OIL CONSERVATION DIVISION

State Section 2 (Apache - NEDU 312S)

SUNDRY NOTICES AND REPORTS ON WELLS

OTHER: TA Renewal ☒

Apache
N.E.D.V. # 312

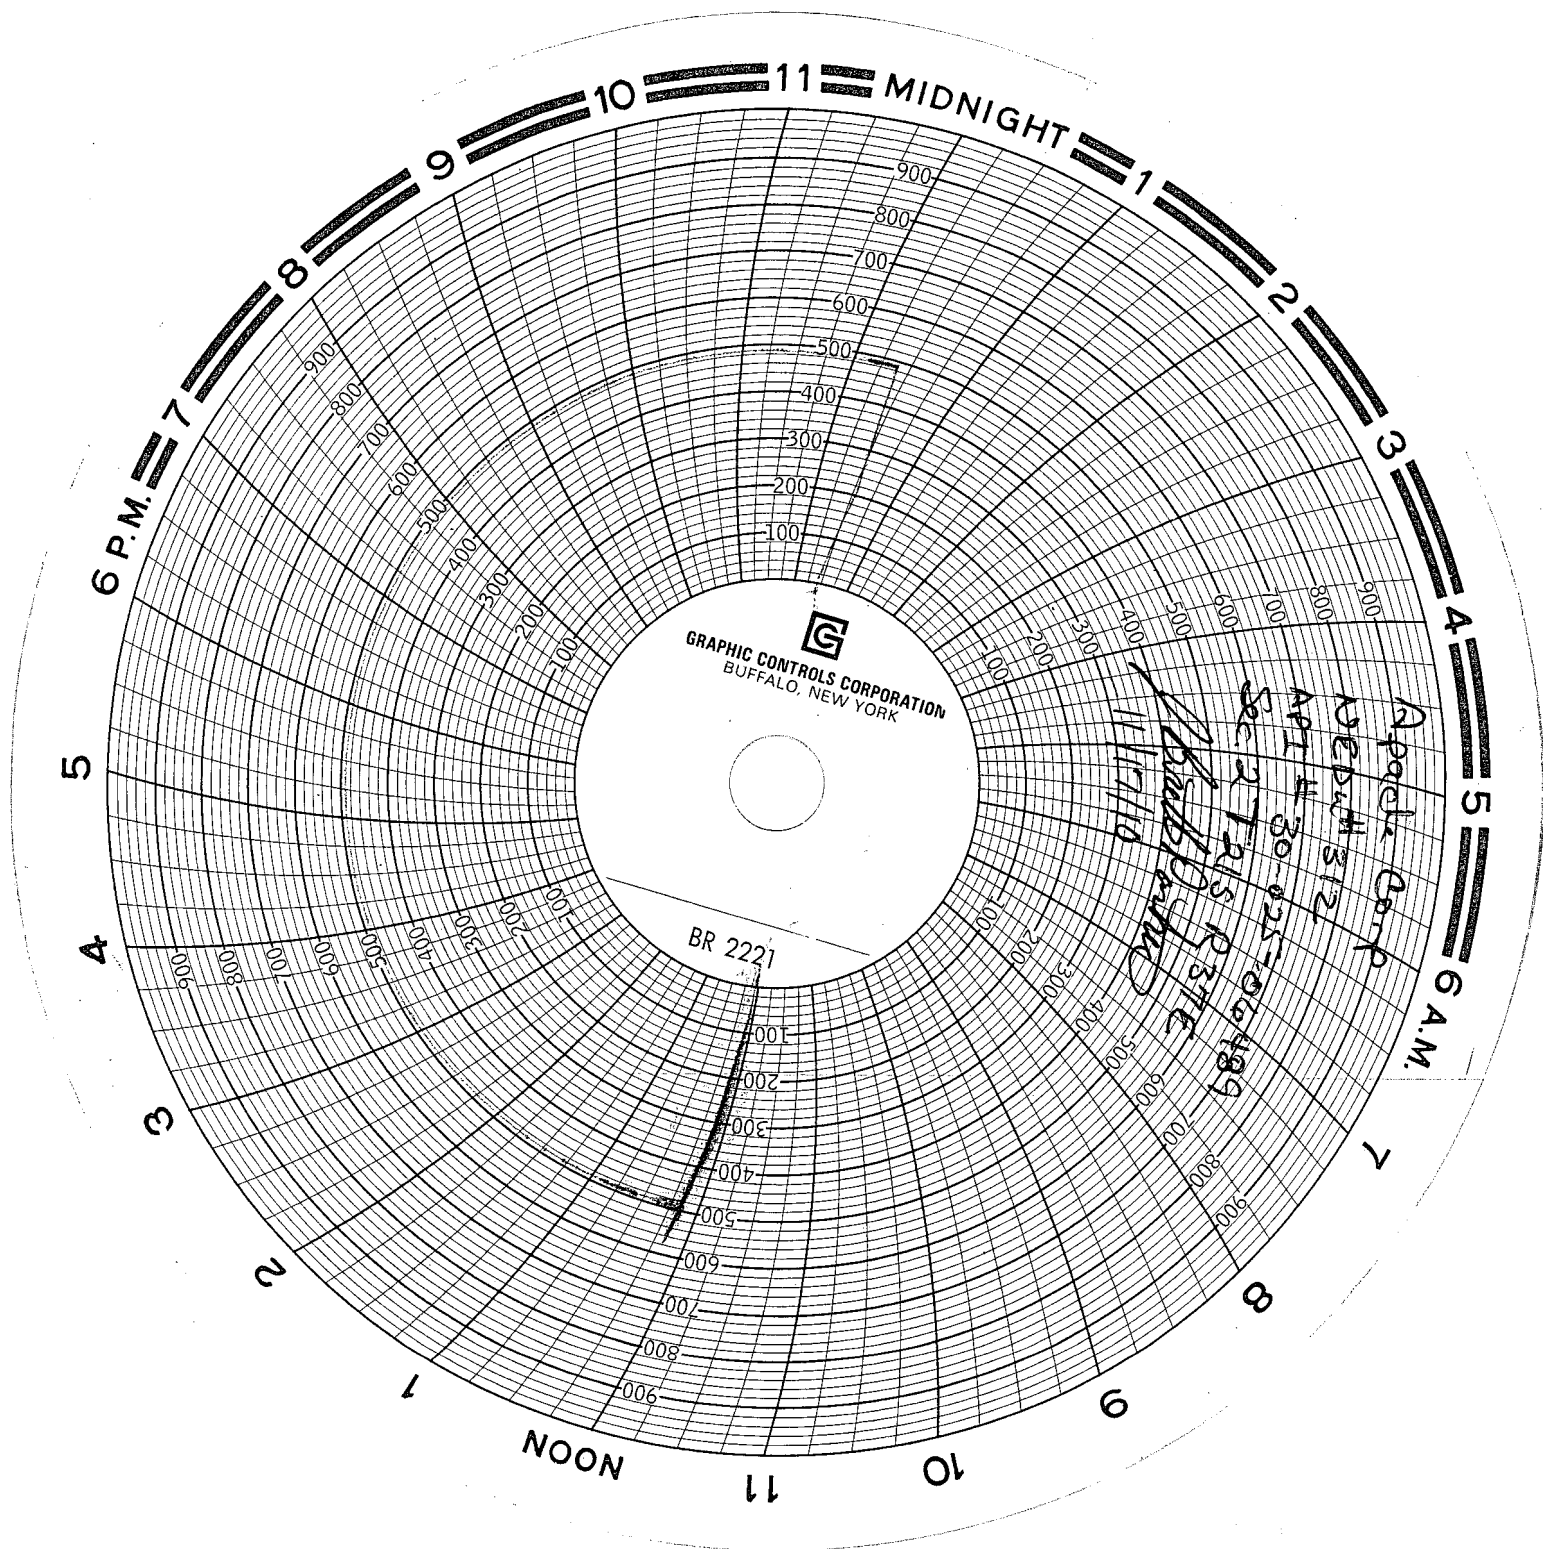
DENIED

Rule 19.15.25.14

Set CIBP, RBP or Packer within 100' of uppermost
perfs. Pressure test to 500psi, for 30 minutes with
a pressure drop of not greater than 10% over a
30 minute period.
